Serial No.: 10/650,422

### **Remarks/Arguments**

### **Amendments to the Drawings**

**Fig. 1**

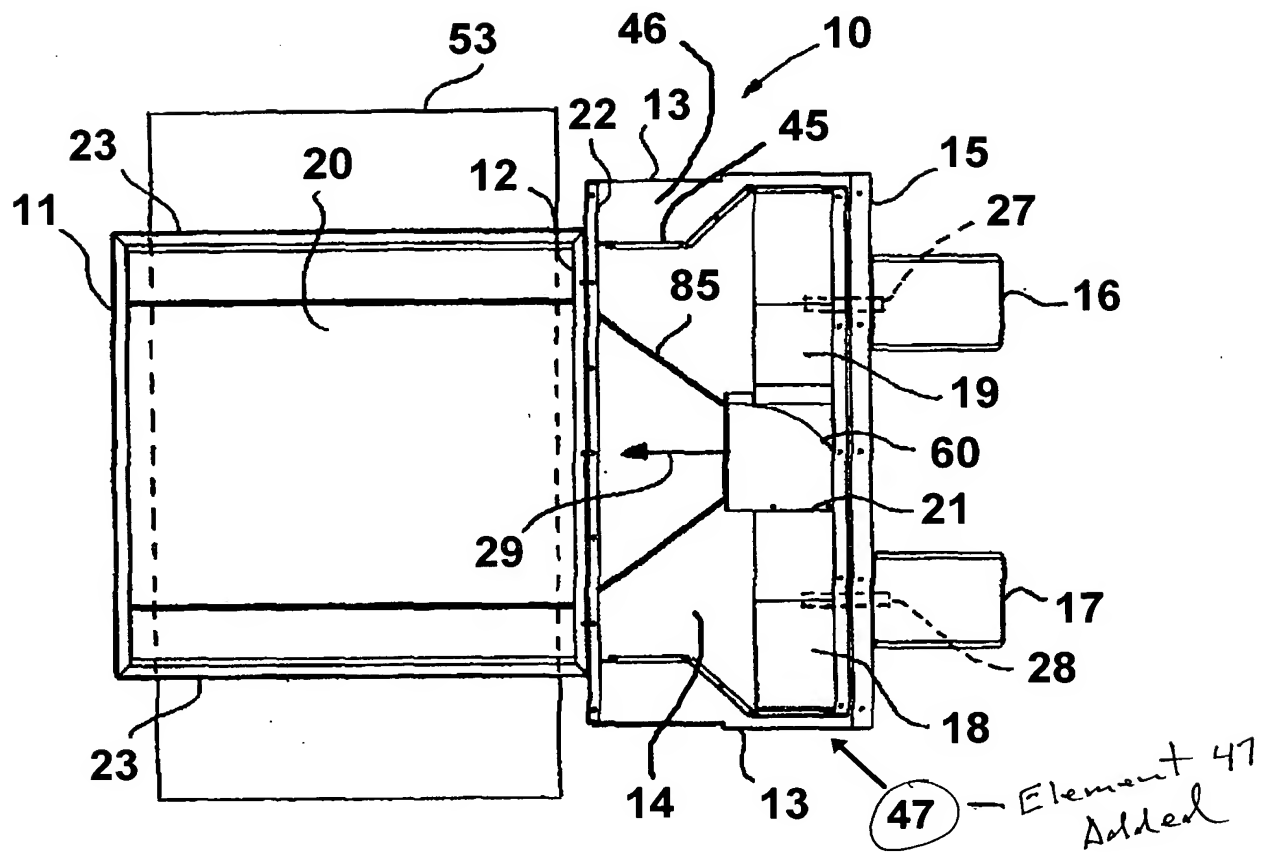
The drawings have been objected to as failing to comply with 37 CFR 1.84(p)(5) because they do not include the reference element 47 mentioned in the description. In response thereto, Applicants have amended Fig. 1 of the drawings by adding the omitted element. Applicants respectfully urge that this amendment to the drawings overcomes this objection.

Applicants have amended Fig. 1 of the drawings by adding the omitted reference element 47, which is indicated, for example, in paragraph [0018] to refer to a blower box.

The attached sheet of drawings includes changes to Fig. 1. This sheet replaces the original sheet containing Fig. 1. In Fig. 1, previously omitted reference element 47 has been added.
